Re: Proposed Subdivision  
37-41 Croton Dam Road  
Ossining, New York

We offer the following responses to the comments prepared by Frederick P. Clark Associates, dated June 20, 2018 and Ciarcia Engineering, P.C., dated September 5, 2018:

Comment memo from David H. Stolman, AICP, PP, Frederick P. Clark Associates, dated June 20, 2018

Comment Memo from Dan Ciarcia, PE, Ciarcia Engineering, P.C, dated September 5, 2018

FIGURE NO. 1  
09/24/2018

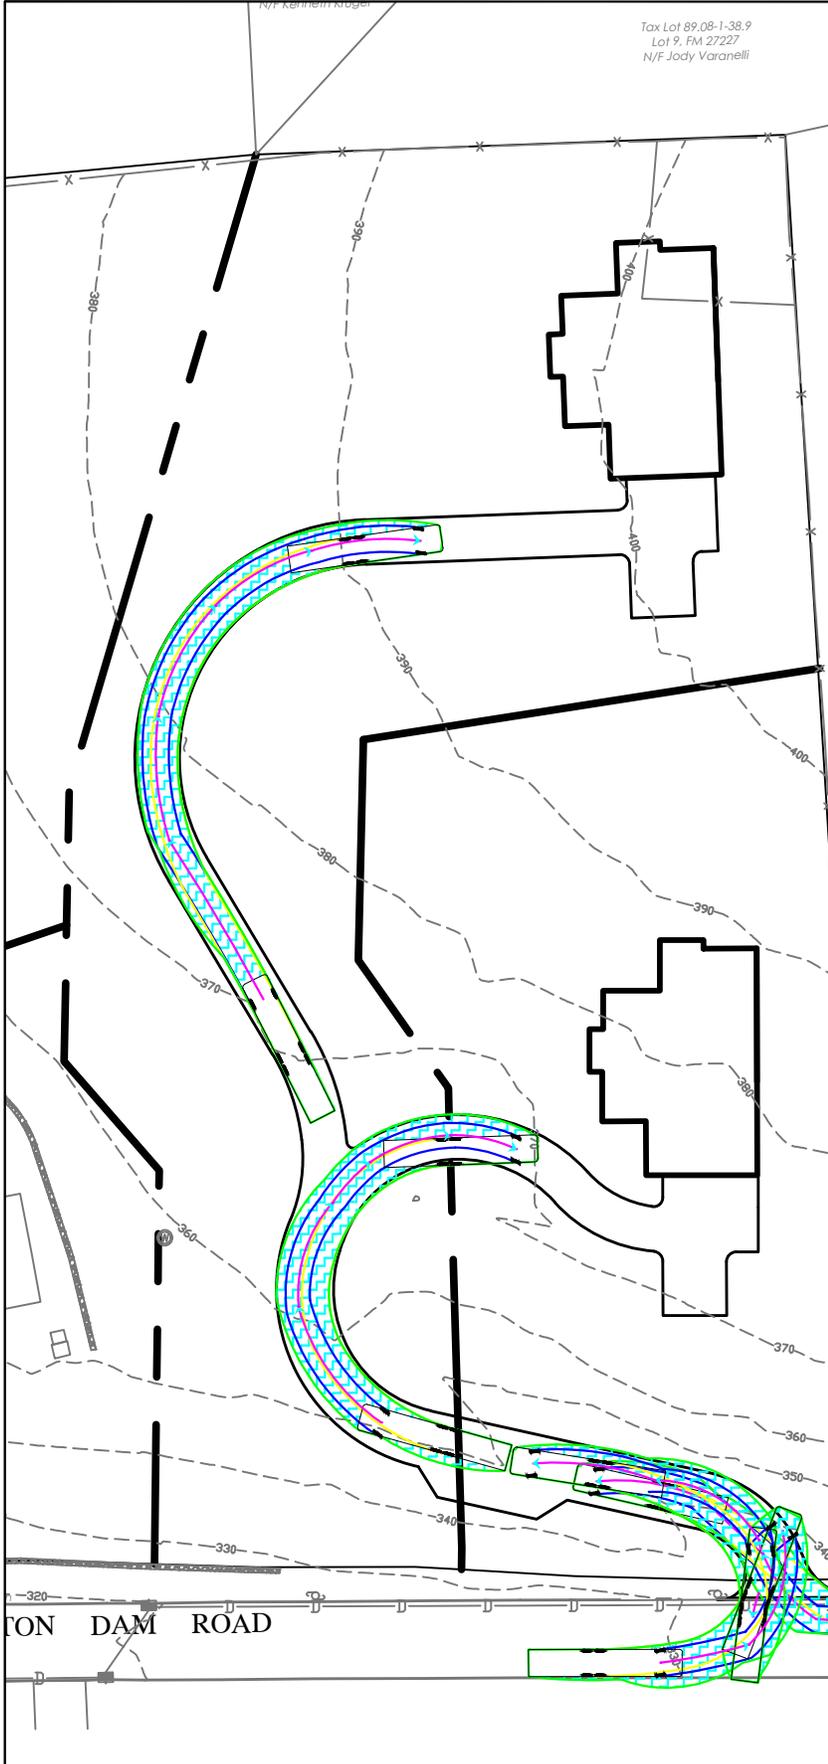
*Comment 1: Provide turning templates on the drawings to verify emergency vehicle access to the two (2) new residences.*

**Response:** A turning movement diagram showing emergency vehicle access to the two new residences is attached to this letter (see Figure 1). The Applicant will meet with the Town Fire Marshal to discuss any further refinements to the proposed access.
